SERVICE BULLETIN

SUBJECT: INSPECTION OF ATTACHMENT OF CABIN WINDOWS
TO FUSELAGE SKIN

BIN WINDOW GASKETS

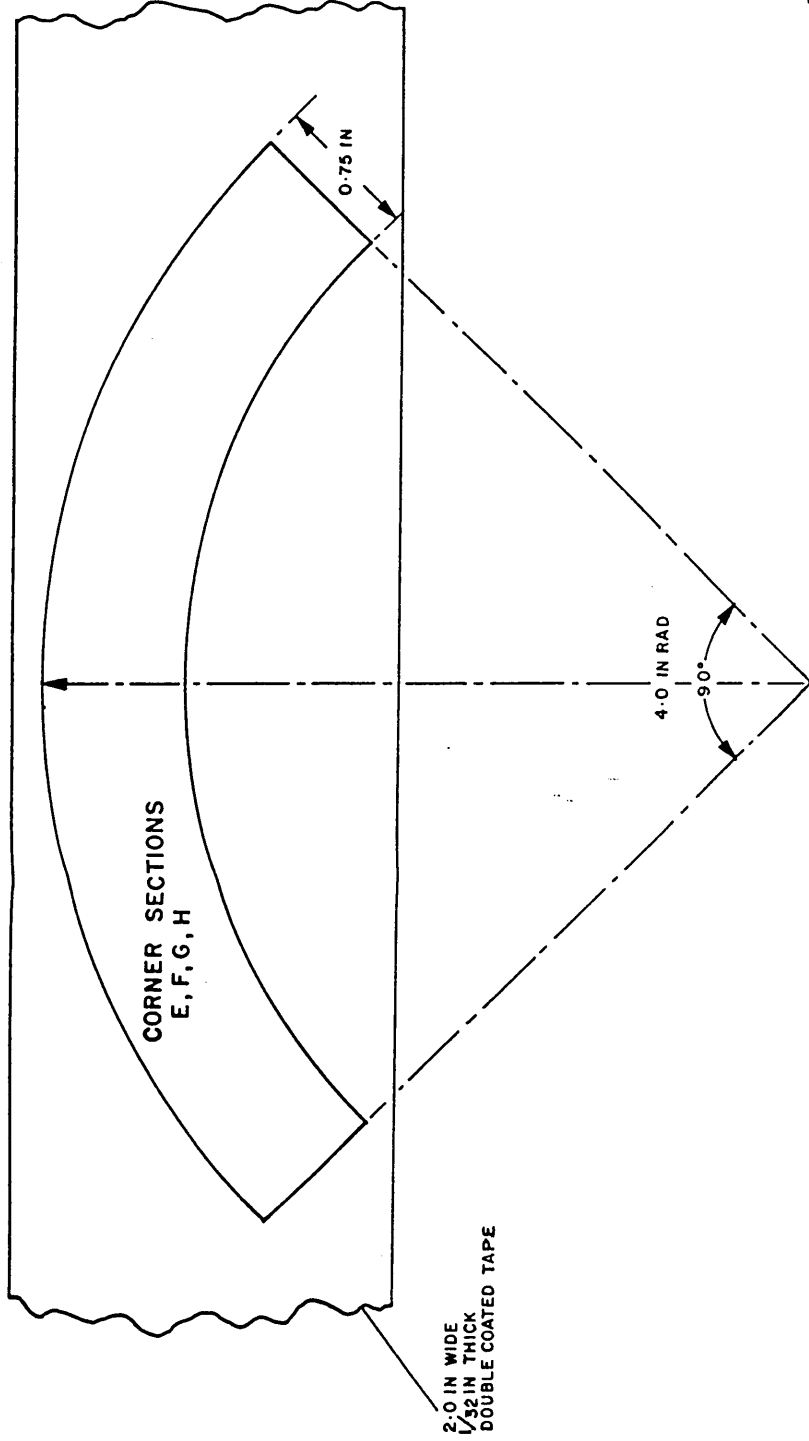
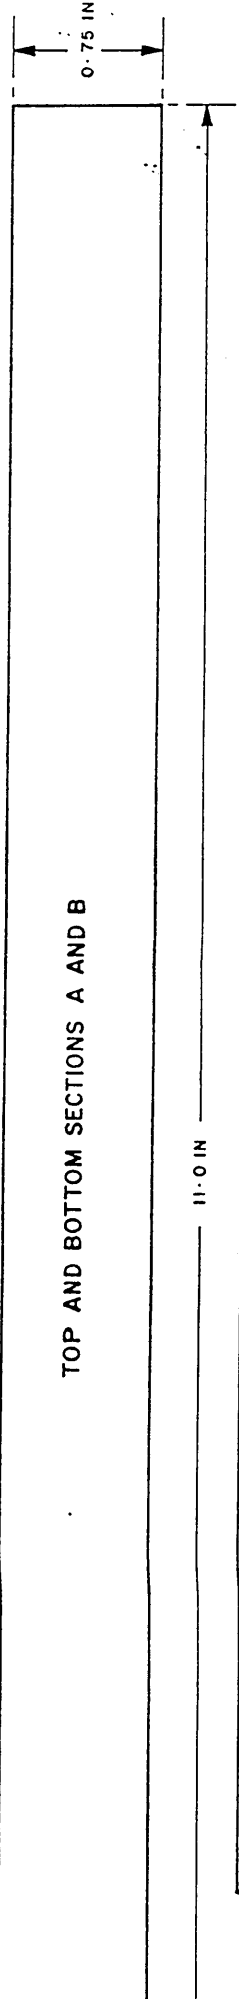
If any signs of window detachment are detected, windows should be re-seated using new double sided adhesive gaskets made from "Scotchmount" double coated tape 4032 using templates in Figure 1. Refer to S.R.M. 56-20-00 for window assembly replacement.

2.0 IN WIDE
1/32 IN THICK
DOUBLE COATED TAPE

ALL SECTIONS FROM
MOUNT DOUBLE COATED
